Errata

This errata sheet is for MB91640A/645A Series Hardware Manual Rev. 1 (CM71-10154-1E).

FR80
 32-BIT MICROCONTROLLER
 MB91640A/645A Series
 HARDWARE MANUAL

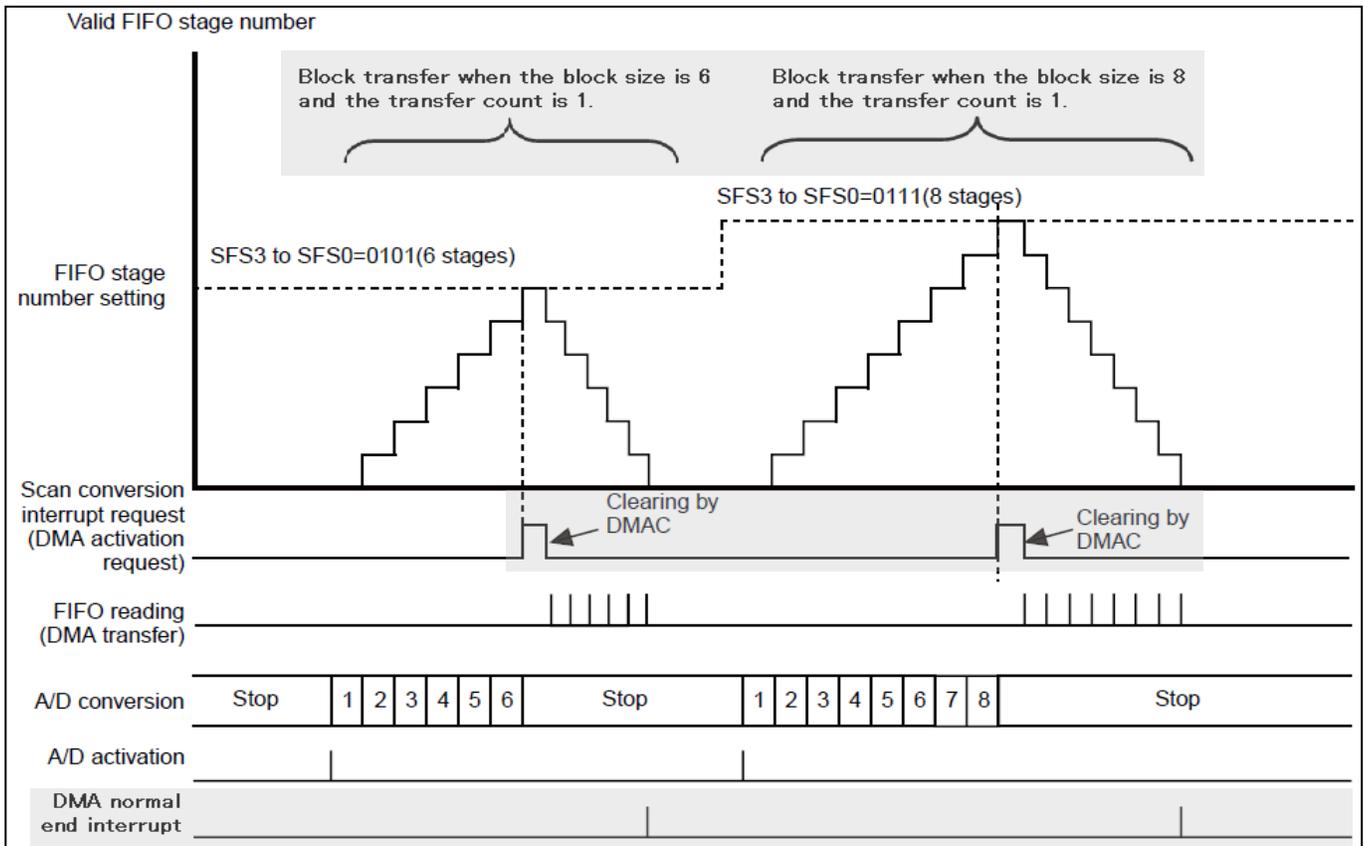
| Date | Page | Item | Description |
|------------|----------|-----------------|--|
| 2010/2/22 | 952 | 27.18 | <p>Added < Attached document 3 > as 27.18.</p> |

2. DMA retransfer operation

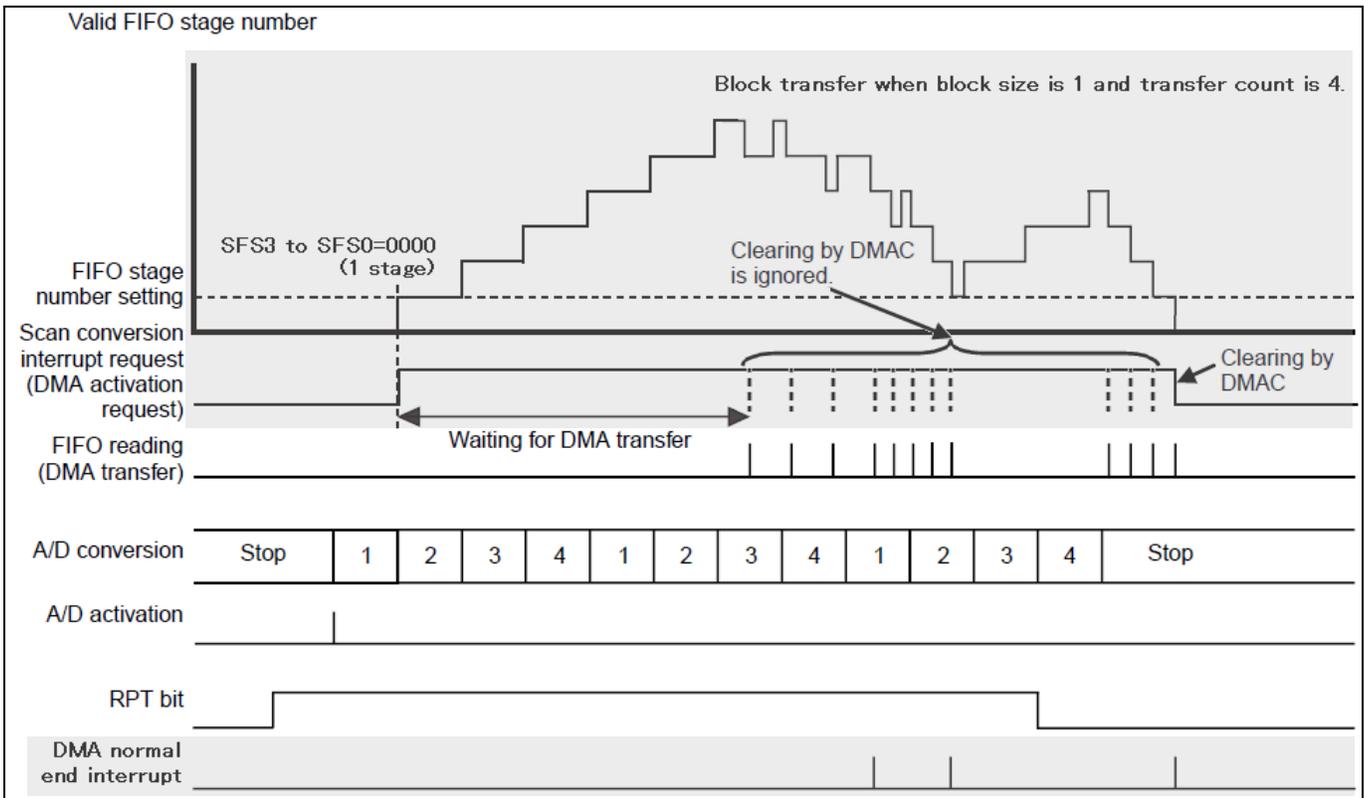
| Date | Page | Item | Description |
|------------|----------|-----------------|--|
| 2010/2/22 | 823 | 25.6.4 | <p>"Figure 25.6-7 DMA retransfer operation" was corrected as 2. in < Attached document 1 >.</p> <p>The following <Note> was added to the lower part of "Figure 25.6-7 DMA retransfer operation".</p> <p>Set 1 to block size of DMA, and 1 for the interrupt generation FIFO stage number.</p> |

Figure 1 INT Bit Change Timing of I²C (WSEL= 0)

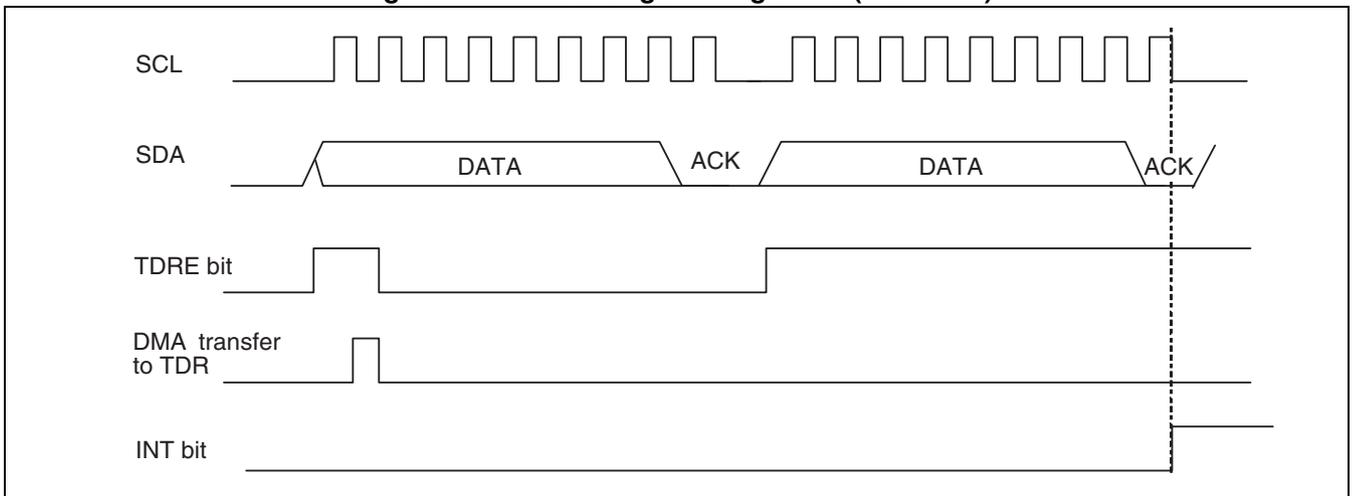
To perform DMA transfer in I²C mode, since the specification is as shown above, such operations listed below are required for performing DMA transfer to TDR before the interrupt flag (INT) becomes "1". Below operations are possible to perform to prioritize DMA transfer of I²C.

- Use DMA which has a higher priority (channel number is small). It is enabled to use by fixing the priority setting bit (AT=0).
- Set the value of DMA-halt by interrupt level bit as small as possible (LVL4-LVL0 bit in DILVR register).

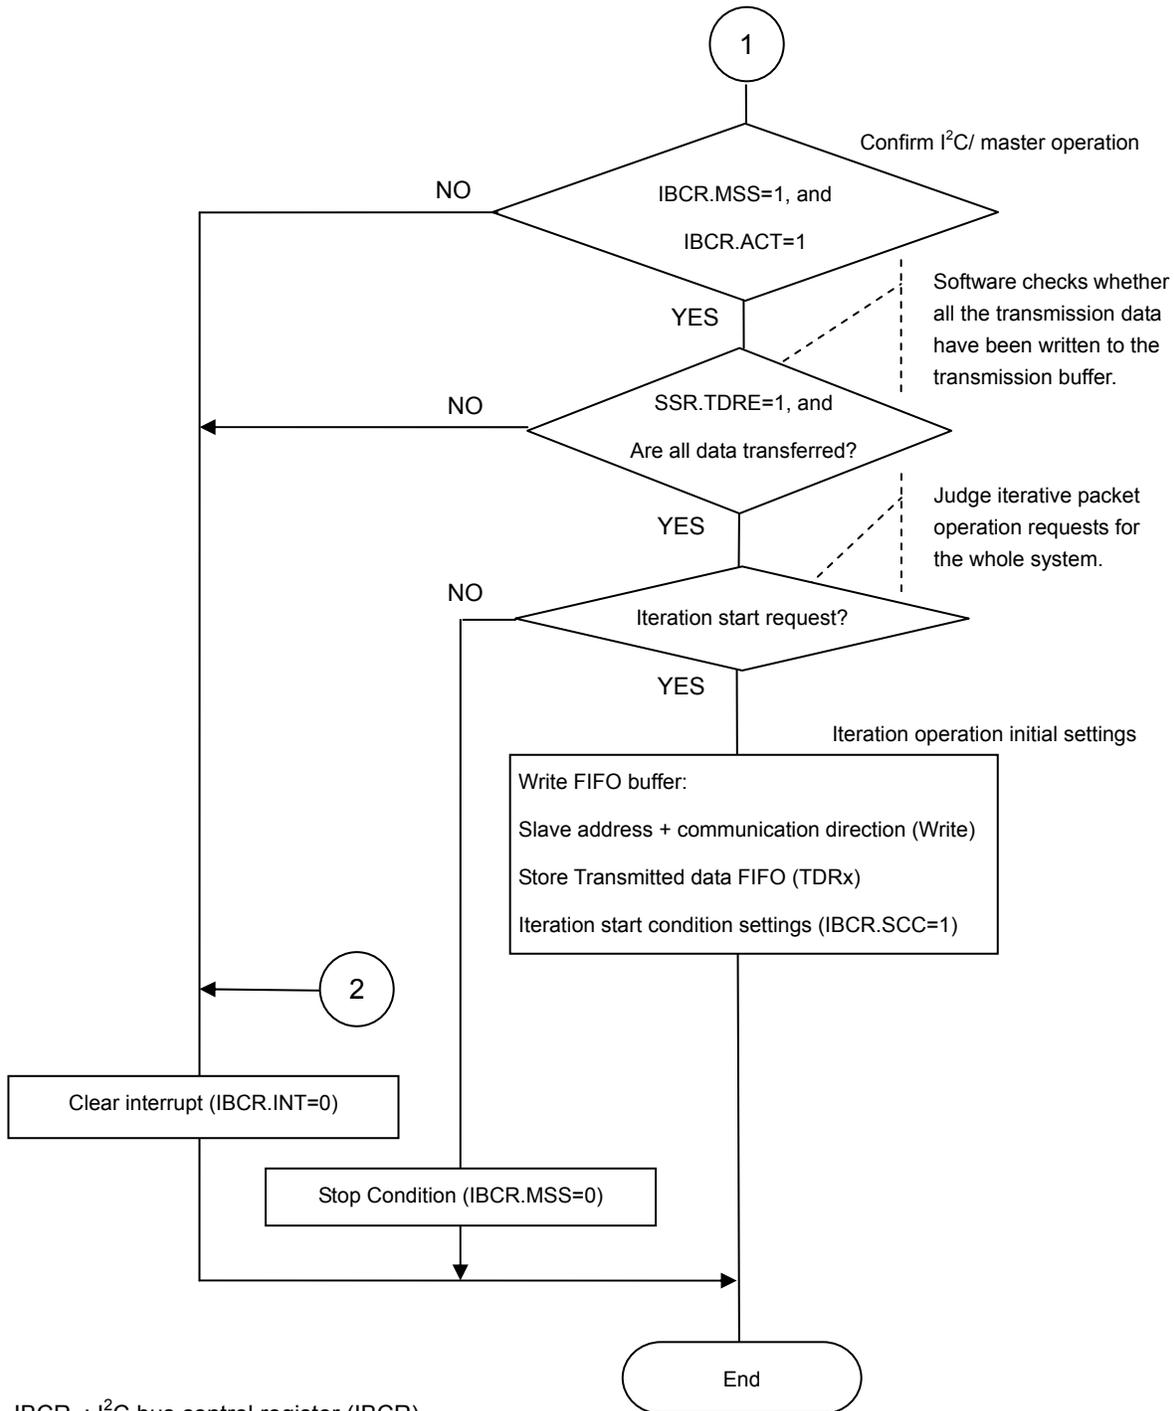
- In case of writing the transmission data to transmission data register (TDR) by DMA transfer after transmission data empty flag (SSR:TDRE) becomes "1", or writing the data by software confirming the transmission data empty flag (SSR:TDRE), transmission data empty flag (SSR:TDRE) may not become "0". Therefore, the transmission data should be written before SCL in ACK field falls. There are no restrictions on writing the transmission data by software after the interrupt flag (IBCR:INT) becomes "1".

When performing DMA transfer or sending the data by software confirming the transmission data empty flag (SSR:TDRE), please follow below procedures if the data cannot be written before SCL in ACK field falls.

Set the timing of interrupt flag (IBCR:INT) becoming "1" to the 8th bit (WSEL=1).

1. Write the first byte (slave address) to the transmission data register by software.
2. Set to 8-bit for wait selection (IBCR:WSEL="1" write) at the same time that master is started (IBCR:MSS="1" write).
3. After sending the first byte, the interrupt flag (IBCR:INT) becomes "1". Write the second byte to transmission data register (TDR) by software after confirming ACK response (IBSR:RACK="0"). Set the DMAC, and activate DMA transfer, then write "0" to interrupt flag (IBCR:INT).
4. After transmission and reception are completed, terminate the master (IBCR:MSS="0" write) or reboot (IBCR:SCC="1" write).
